ECE/TRANS/WP.29/GRB/2007/3
8 December 2006

World Forum for Harmonization of Vehicle Regulations

Working Party on Noise

PROPOSAL FOR DRAFT AMENDMENTS TO REGULATION No. 51

Figure 2: Reference point"

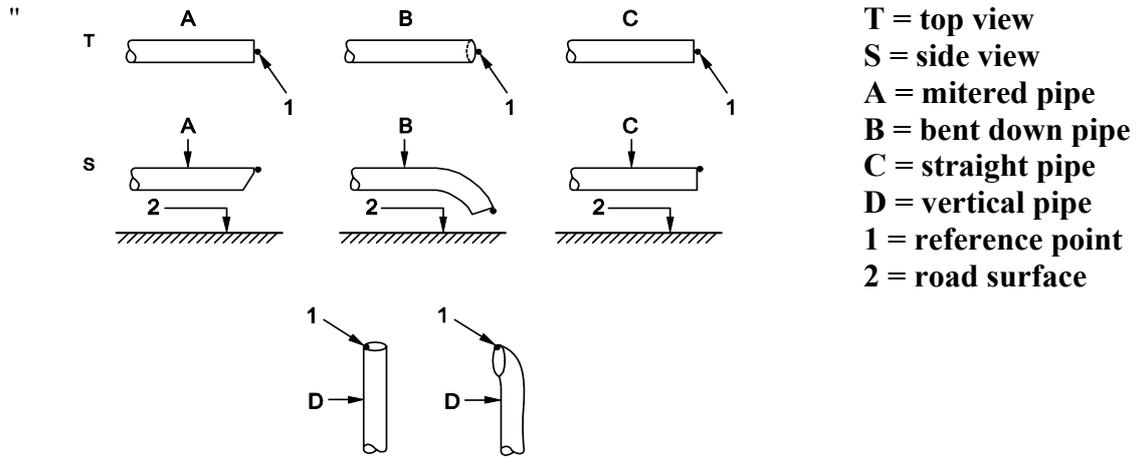
3.2.5.3.1.1. **The microphone shall be located at a distance of 0.5 m ± 0.01 m from the reference point of the exhaust pipe defined in figure 2 and at an angle of 45 ° (± 5 °) to the vertical plane containing the flow axis of the pipe termination. The microphone shall be at the height of the reference point, but not less than 0.2 m from the ground surface. The reference axis of the microphone shall lie in a plane parallel to the ground surface and shall be directed towards the reference point on the exhaust outlet.**

- 3.2.5.3.1.4. For vehicles with a vertical exhaust (e.g. commercial vehicles) the microphone shall be placed at the height of the exhaust outlet. Its axis shall be vertical and oriented upwards. It shall be placed at a distance of $0.5 \text{ m} \pm 0.01 \text{ m}$ from the exhaust pipe reference point as defined in figure 2, but never less than 0.2 m from the side of the vehicle nearest to the exhaust.

Annex 3 - Appendix, insert a new figure 2 to read:

Figure 3a

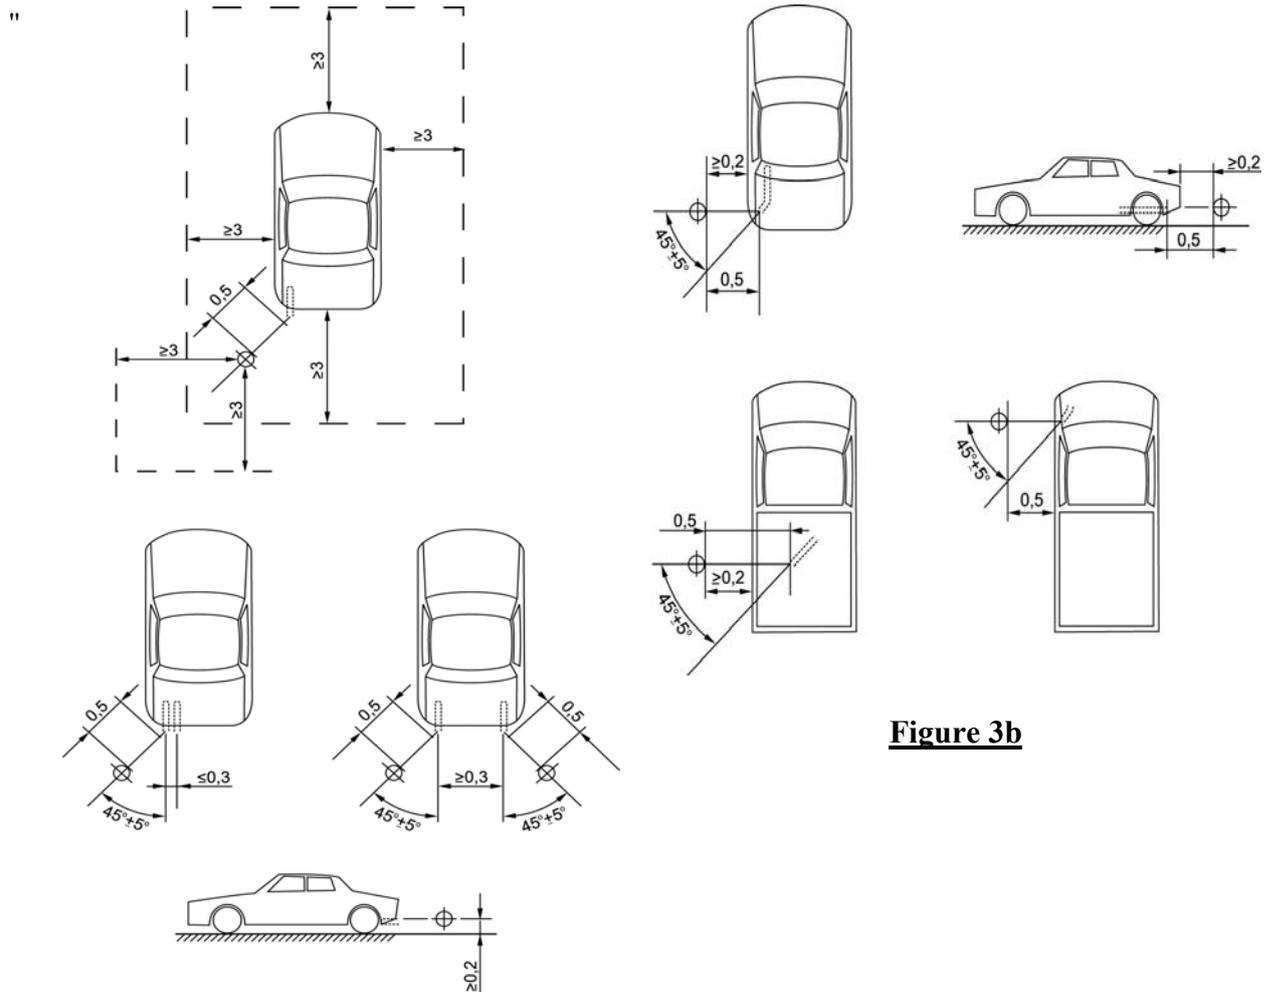
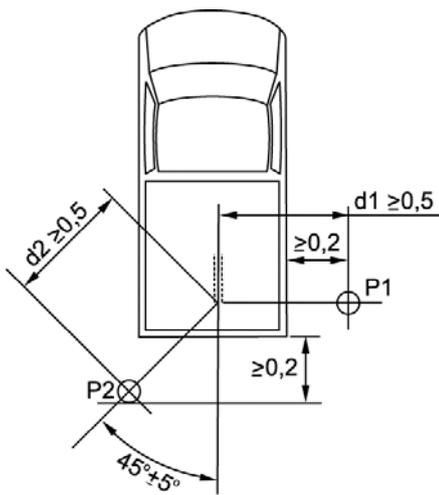
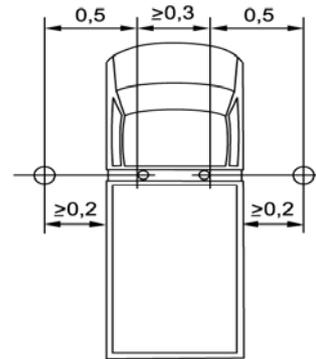
- 3.2.5.3.1.5. For vehicles, where the reference point of the exhaust pipe is not accessible, or located under the vehicle body, as shown in figures 3b and 3c, because of the presence of obstacles which form part of the vehicle (e.g. spare wheel, fuel tank, battery compartment), the microphone shall be located at least 0.2 m from the nearest obstacle, including the vehicle body, and its axis of maximum sensitivity shall face the exhaust outlet from the position least concealed by the above mentioned obstacles.

When several positions are possible, as shown in figure 3c, the microphone position giving the lowest value of d1 or d2 shall be used.

Note: Figures 3a to 3d show examples of the position of the microphone, depending on the location of the exhaust pipe."

Annex 3 - Appendix, figure 2 (former), renumber as figures 3a to 3d and amend to read:
